Project	IEEE 802.16 Broadband Wireless Access Working Group < <u>http://ieee802.org/16</u> >
Title	Corrections and clarifications on periodic ranging process in OFDMA.
Date Submitted	2005-05-02
Source(s)	Joël Demartyjoel@sequans.comSEQUANS Communications.Voice: +33 1 44 89 48 07
	Ambroise PopperSEQUANS Communicationsambroise@sequans.com
Re:	IEEE P802.16/Cor1/D2
Abstract	This contribution proposes some corrections and clarifications on periodic ranging process in OFDMA.
Purpose	Adopt changes.
Notice	This document has been prepared to assist IEEE 802.16. It is offered as a basis for discussion and is not binding on the contributing individual(s) or organization(s). The material in this document is subject to change in form and content after further study. The contributor(s) reserve(s) the right to add, amend or withdraw material contained herein.
Release	The contributor grants a free, irrevocable license to the IEEE to incorporate material contained in this contribution, and any modifications thereof, in the creation of an IEEE Standards publication; to copyright in the IEEE's name any IEEE Standards publication even though it may include portions of this contribution; and at the IEE

Figure 90-Periodic CDMA ranging-SS

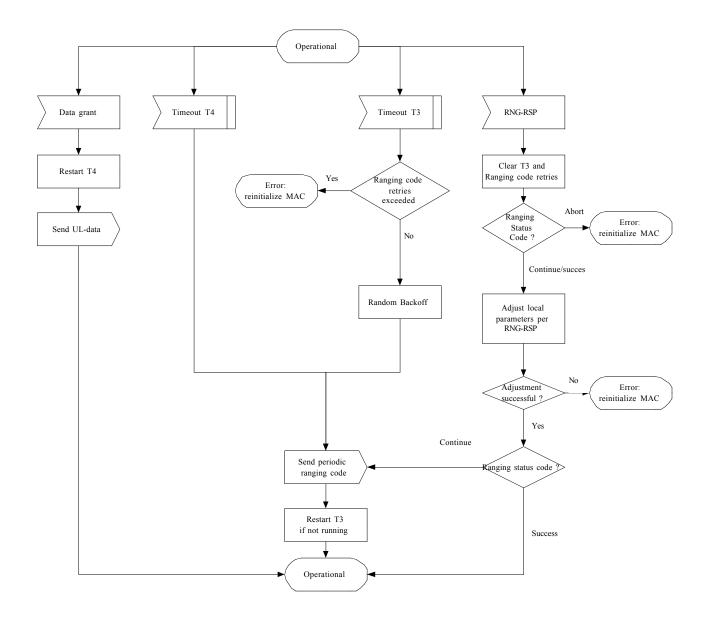
In 802-16-2004, there are ambiguities in the description of the OFDMA periodic ranging process on the SS. The ambiguities are mainly located in figure 90, which described the finite state machine at the SS responsible for the periodic ranging process.

- The figure and the text state that the SS sends a ranging code. The text mentions a periodic ranging domain which is not defined. More precisely, the spec should state that the SS sends a periodic ranging code.

- The figure does not show the back-off mechanism contrary to the figures describing the initial ranging process, which may lead to the erroneous conclusion that there is no backoff in periodic ranging.

- T4 is the SS version of the T27 timer at the BS. T4 should then be restarted only when there is data grant to the SS. In the current state of the standard, T4 is restarted automatically after a T4, which does not look correct.

- T3 controls the time before the reception of the RNG-RSP. It's orthogonal to T4 counter. T3 should be cleared after a RNG-RSP is received and started when the first periodic ranging code is sent to the BS.

- When a RNG-RSP is received, the SS should clear its retry counter.

### Replace figure 90 with the following figure
